As of today, August 17th, 2026, design changes are in effect for series [C3RWT](#) and [C3RWTG](#) 3R wiring troughs. These updates aim to streamline installation and use of the trough.

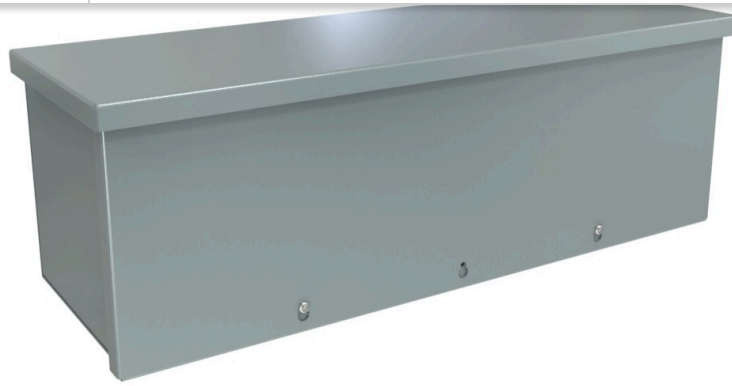
Changes to the design include:

- Padlocking hasp removed
- Keyhole cover slot with self-tapping screw replaces clipnuts
- Rear mounting holes no longer raised (embossed)
